Atty Docket No.: JCLA11476-R

Serial No.: 10/695,018

**REMARKS****Present Status of the Application**

FIG. 1A (PRIOR ART)

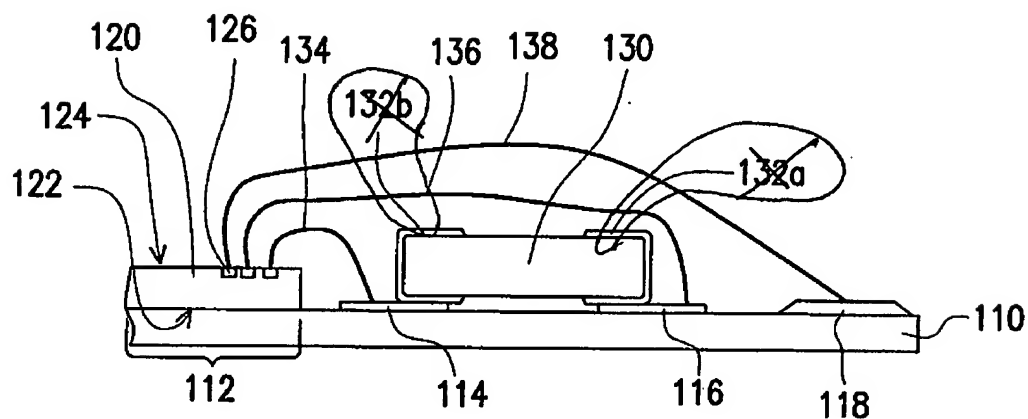
Please amend Figures 1A, 1B, 2A, and 2B according to the replacement drawings as attached herewith.

In response thereto, Applicants have amended Figures 1A, 1B, 2A, and 2B to clarify the dispositional relationships between the passive component and the electrodes 132b and 232b and to clarify that the electrodes are at the top end and bottom end of the passive element. Withdrawal of the objection is respectfully requested.

FIG. 1B (PRIOR ART)

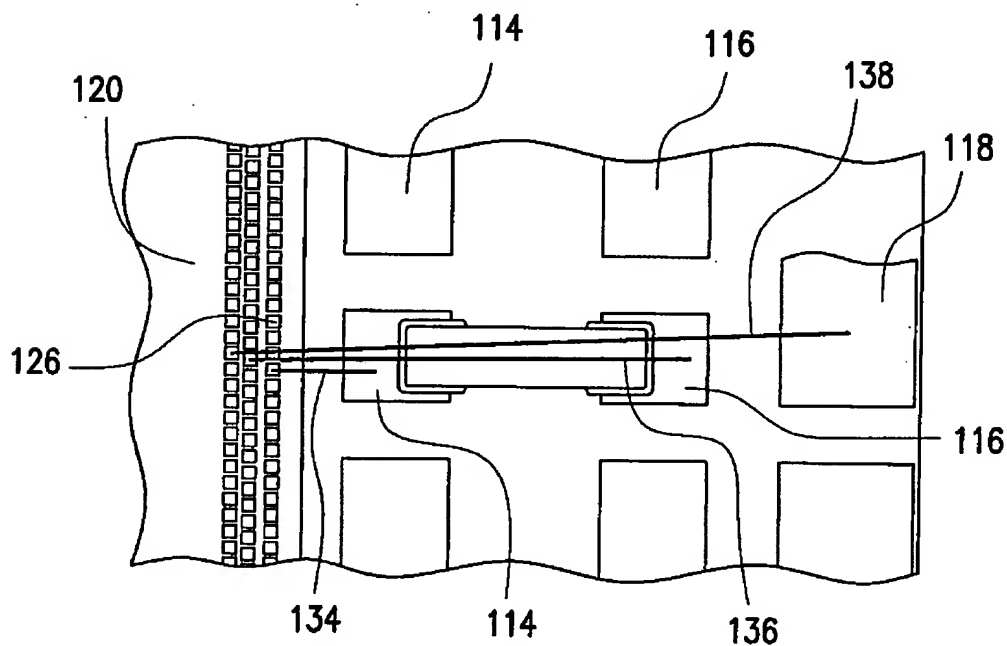
*Figures 1B and 2B are objected to as failing to comply with 37 CFR 1.83(a) because they show inconsistent dispositional relationships between the passive component and the electrodes 132b and 232b and it is not clear whether the electrodes are at the top end of the passive element or at the sides thereof.*
